Addendum No. 3

Bid / Request for Proposal Call No. T2024-220 Construction of the Fire station

This Addendum forms part of the Bid/Proposal Document.
(Question 1-95 had already been replied in Addendum 01 and 02)

BRAMPTON FIRE STATION 215

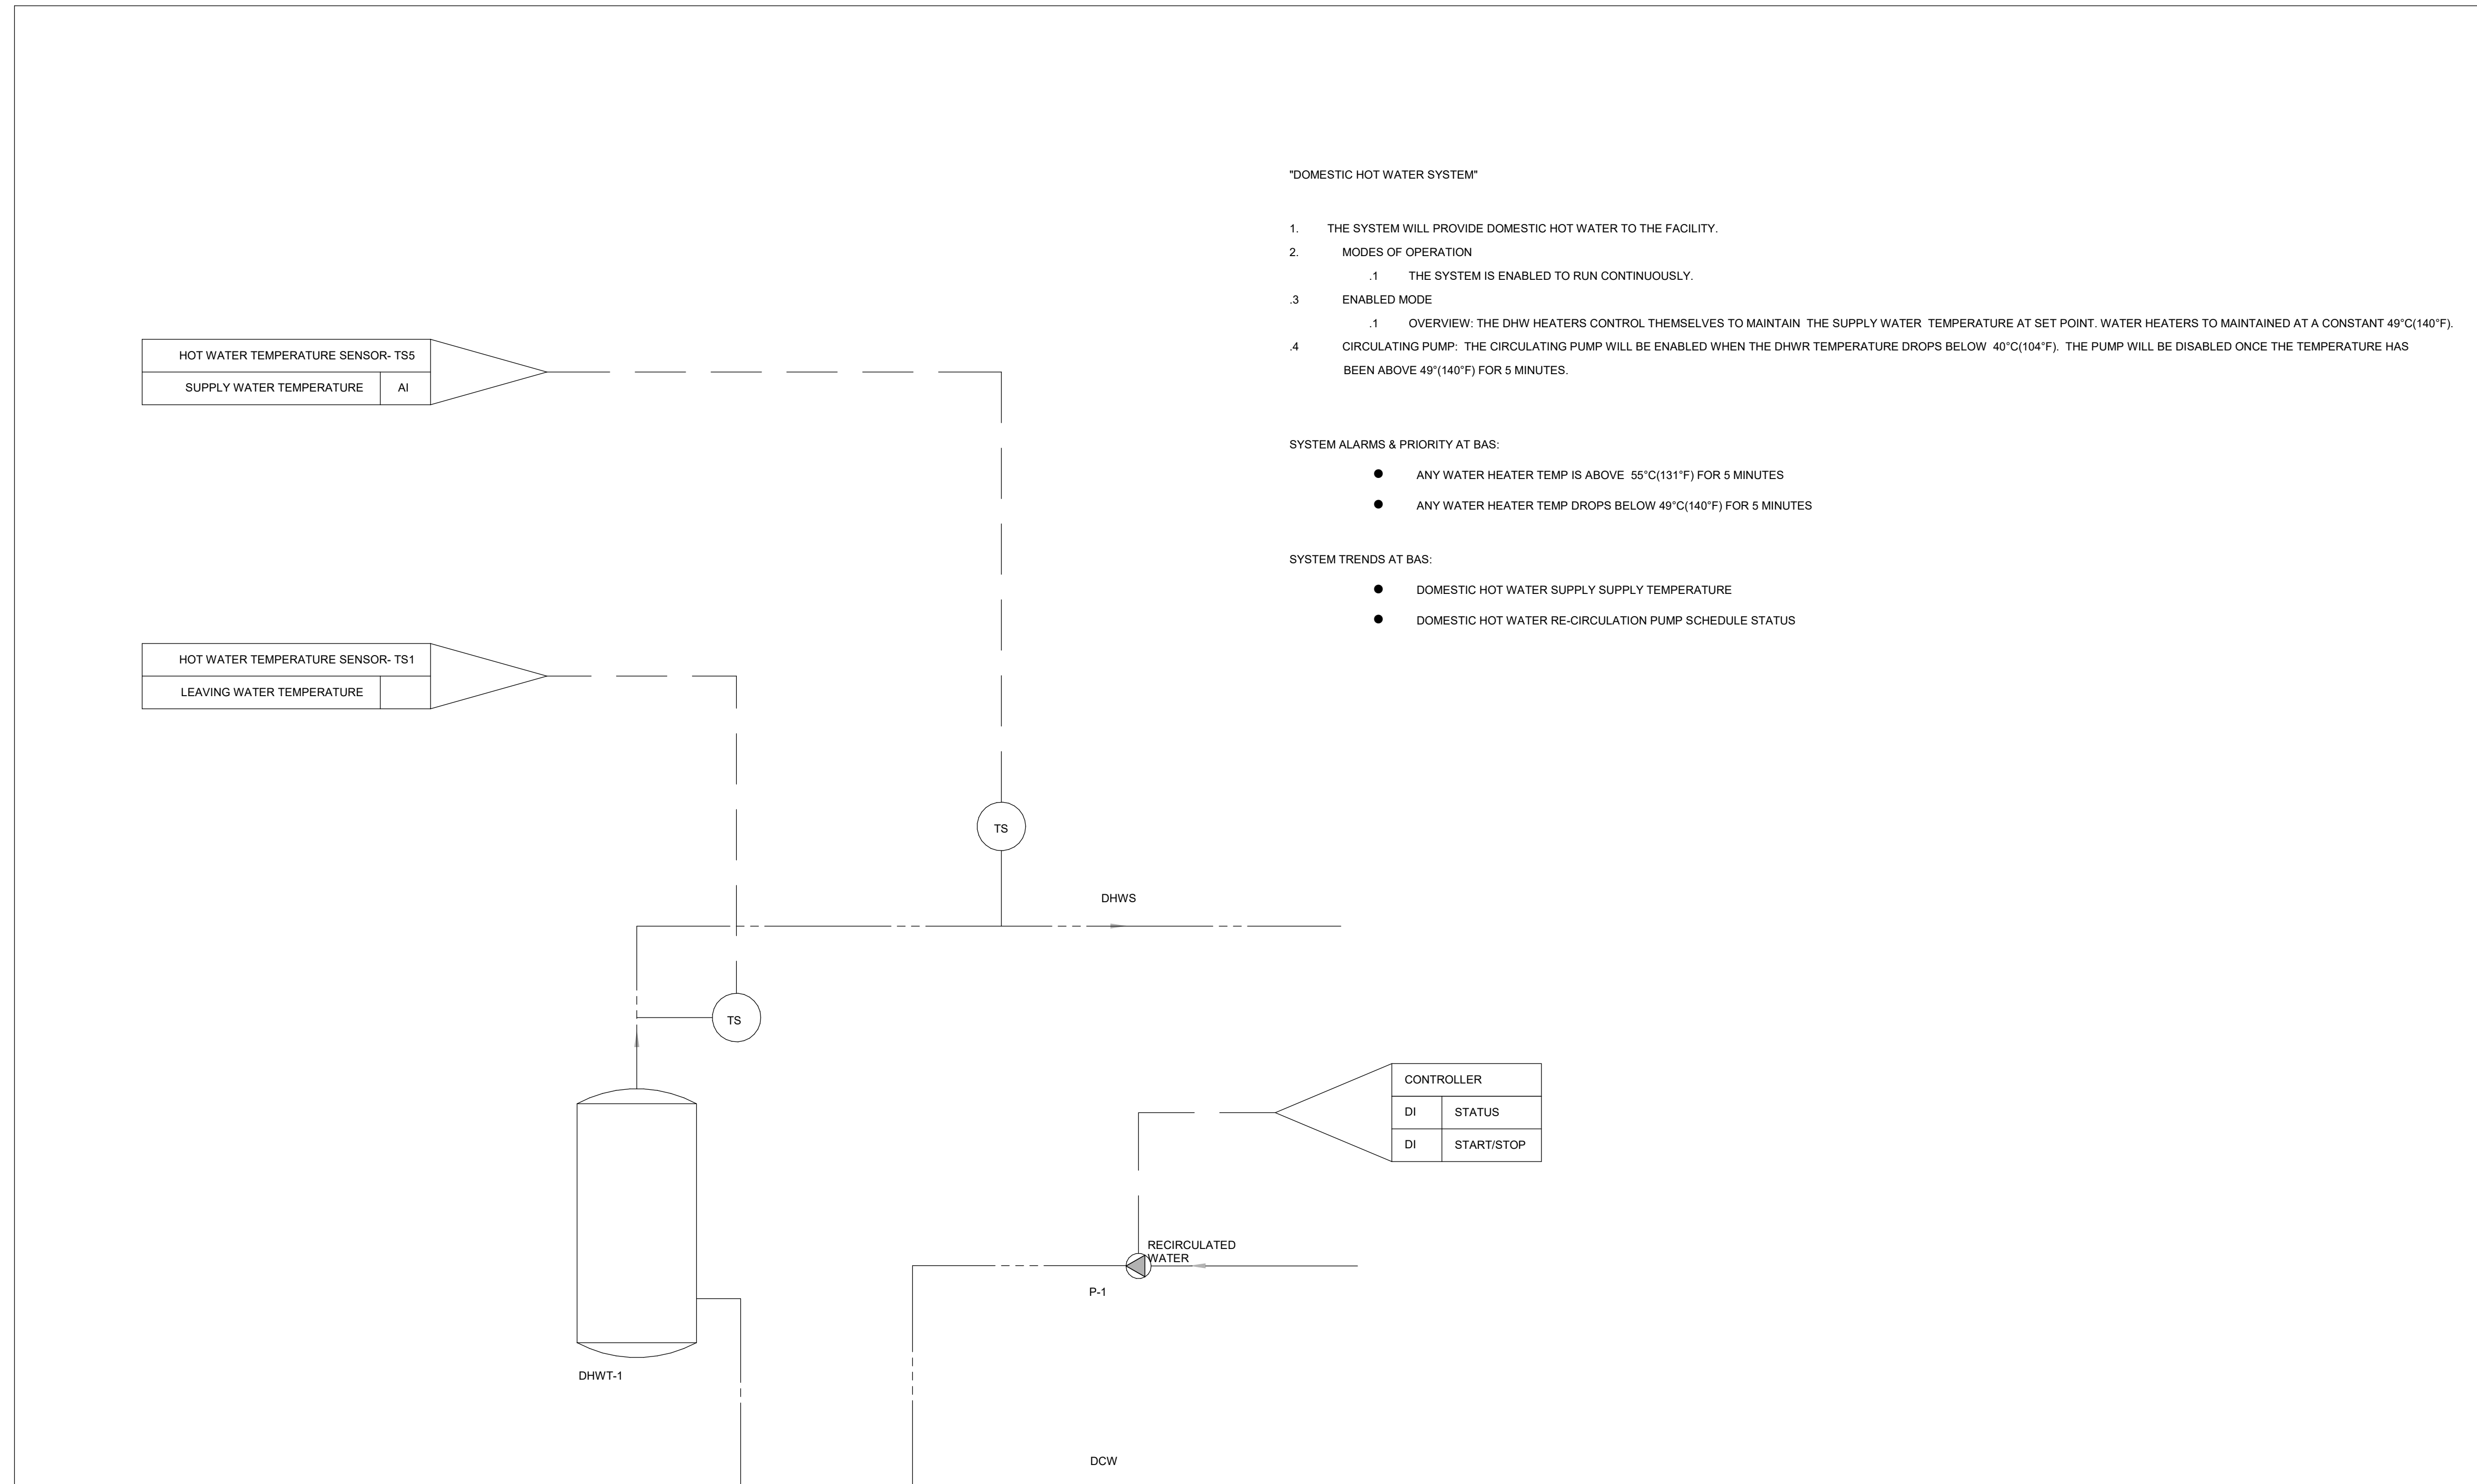
- .1 Drawing M-301 – LEVEL 01 PLAN - VENTILATION**
- i) Added tagging for exhaust tail pipe guide rail.
 - ii) Added symbol for SO2
- .2 Drawing M-751– MECHANICAL CONTROL SEQUENCES I**
- i) Updated apparatus bay fan control sequence
 - ii) Updated ceiling mounted destratification fan(HVLS) control sequence
- .3 Drawing M-753– MECHANICAL CONTROL SEQUENCES III**
- i) Added domestic hot water tank control sequence
- .4 Drawing M-754– MECHANICAL CONTROL SEQUENCES IV**
- i) Added VRF fan coil unit control sequence
 - ii) Added energy recovery ventilators control sequence
 - iii) Added desiccant dehumidifier control sequence
 - iv) Added kitchen exhaust fan control sequence
- .5 Drawing M-755– MECHANICAL CONTROL SEQUENCES V**
- i) Added Exhaust Fan (EF-2, EF-3, EF-4 & EF-6) control sequence
 - ii) Added DX fan coil unit control sequence

- 3. A03.11 – LEVEL 01 - FINISHES PLANS**
.i Delete issued for Tender drawing A03.11 in its entirety and substitute drawing A03.11 barring revision 8 appended to this document.

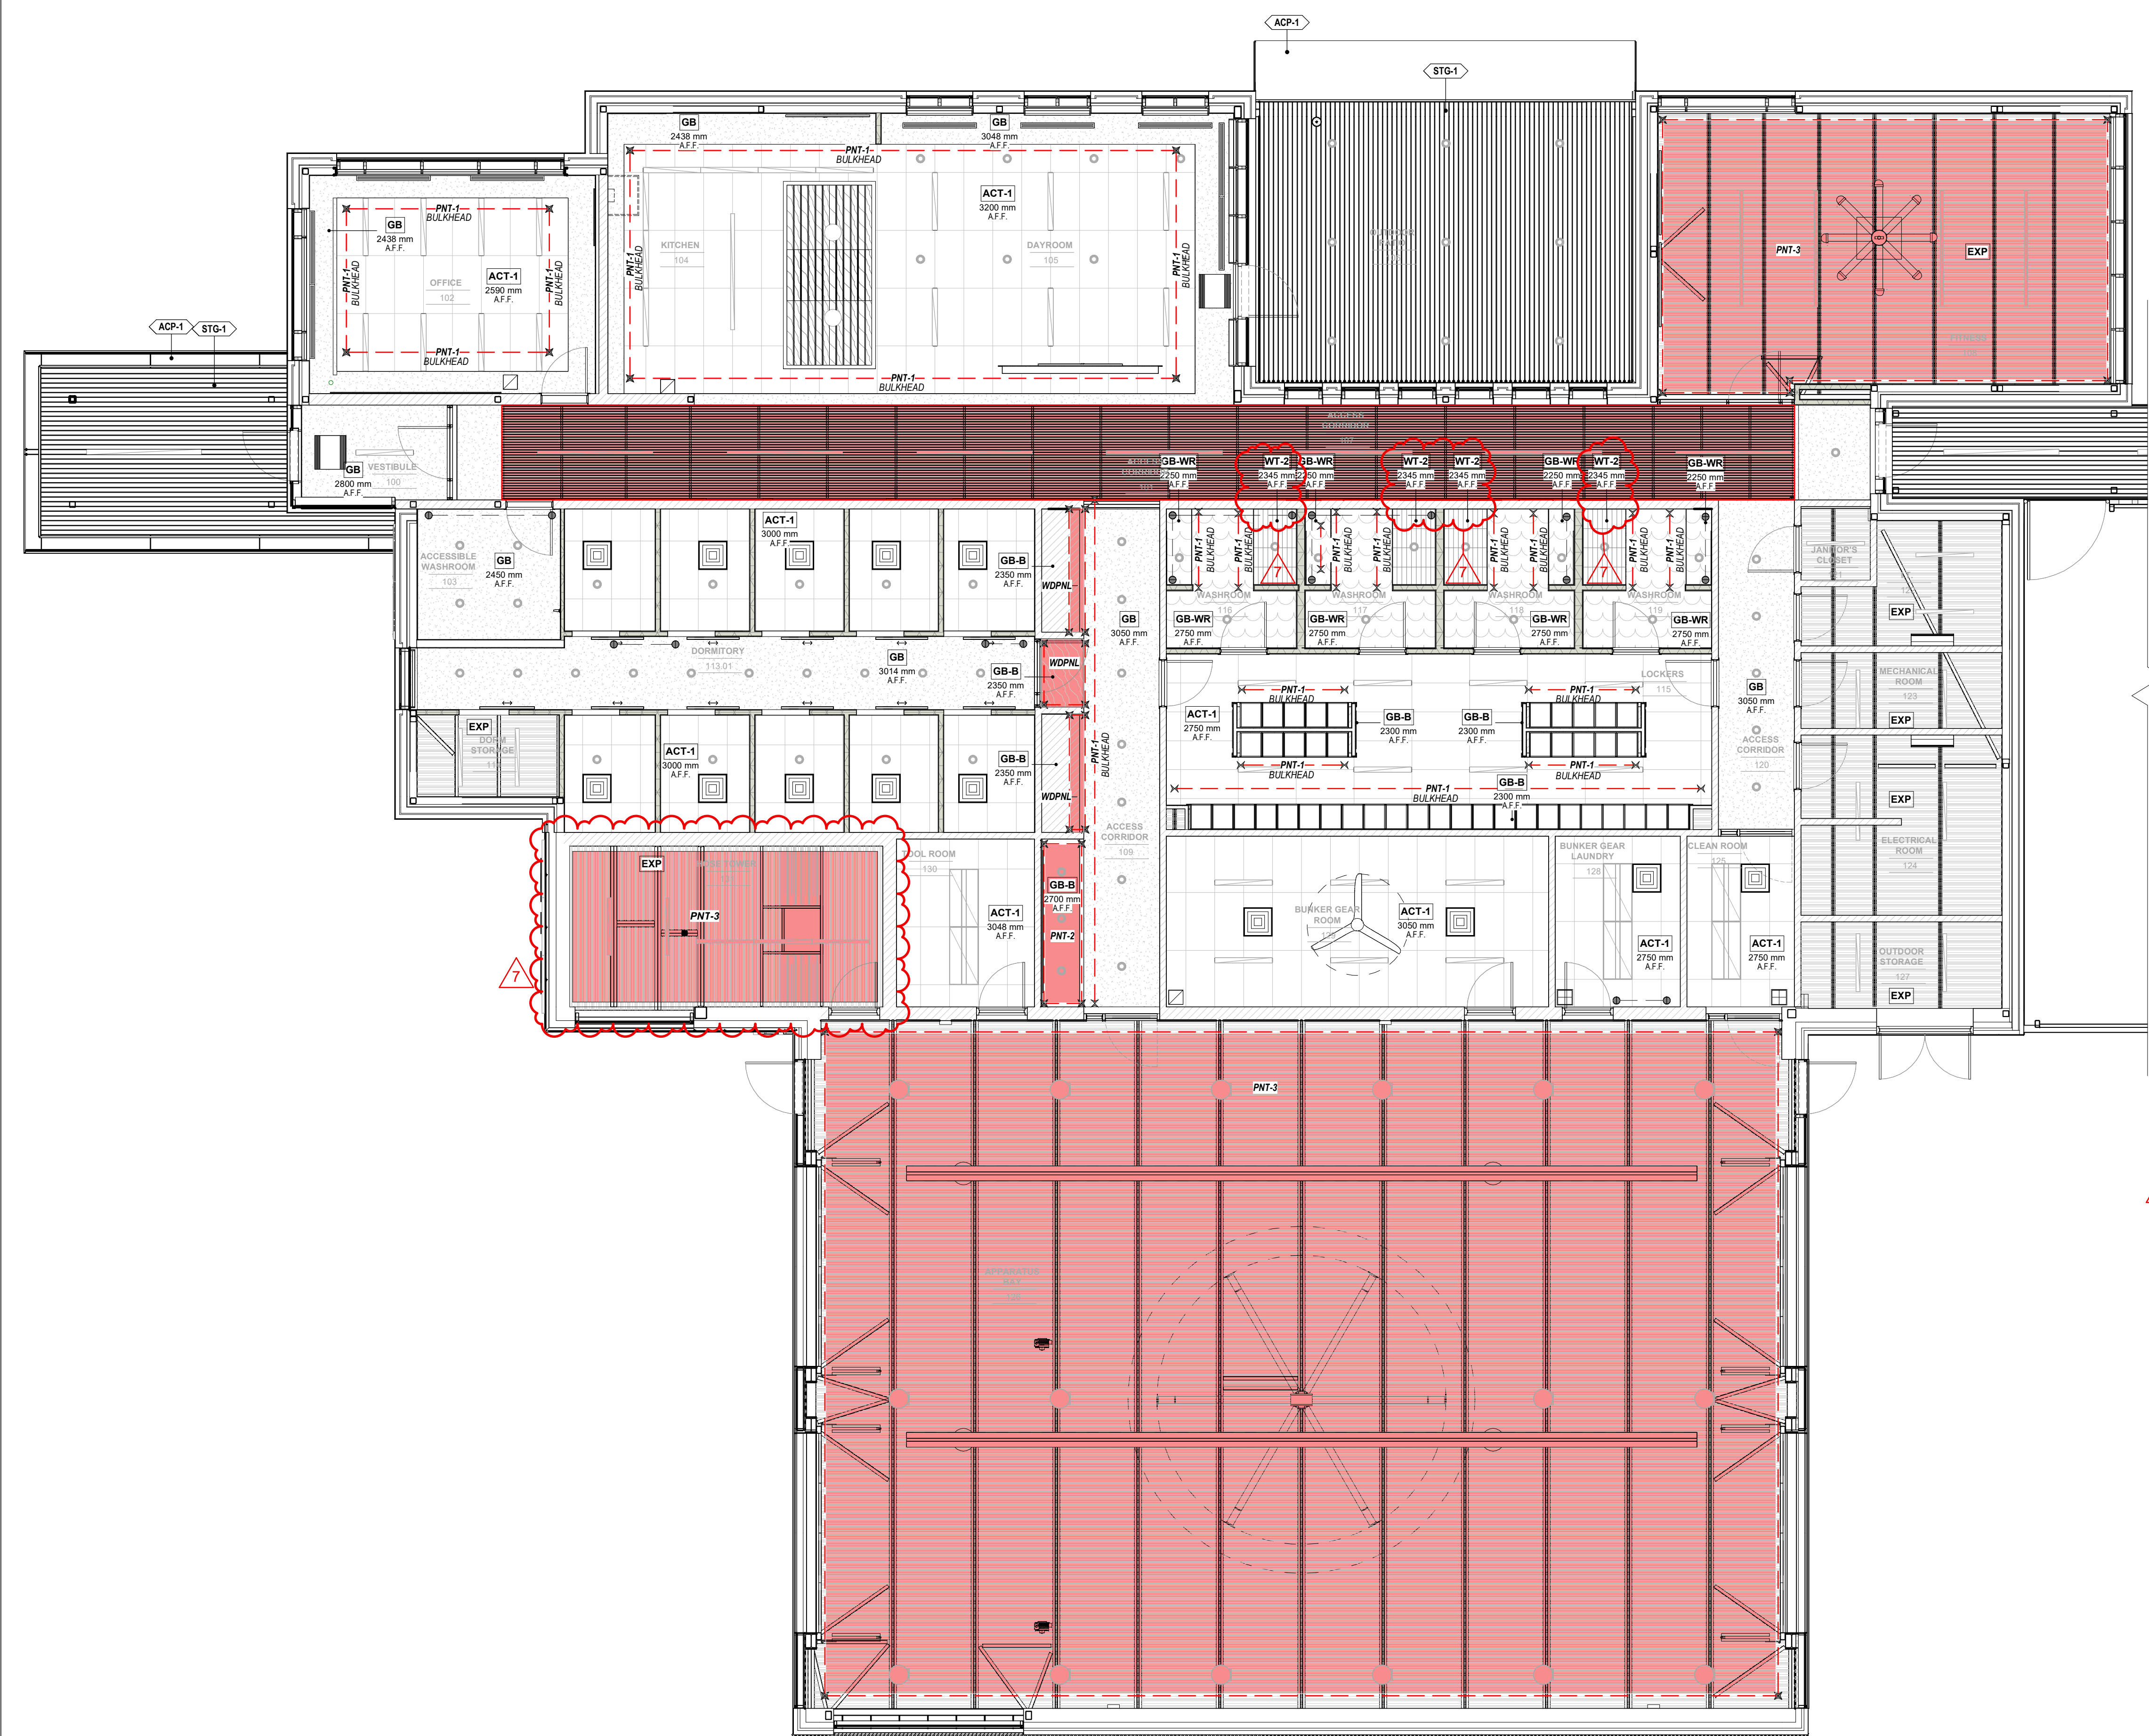
As per the drawing A03.11 Level 01- Finishes Plan, Accessible Washroom 103 have all walls with wall tile WT-1 after finished floor level. (There is no wall base). But drawing A08.01 - Washroom Plans & Elevations, Elevations 2,3,4 & 5 shows wall base line and there is no wall tiles in elevation 2 (wall along with door side). Please clarify.

1. As per the drawing A03.11 Level 01- Finishes Plan, Accessible Washroom103 having all walls with wall tile WT-1 after finished floor level. (There is no wall base). But drawing A08.01 - Washroom Plans & Elevations, Elevations 2,3,4 & 5 shows wall base line and there is no wall tiles in elevation 2 (wall along with door side). Please clarify

Refer to issued drawing A03.11 - Level 01 - Finishes Plans attached herein of this addendum.

Refer to issued drawing A03.11 - Level 01 - Finishes Plans attached herein of this addendum.
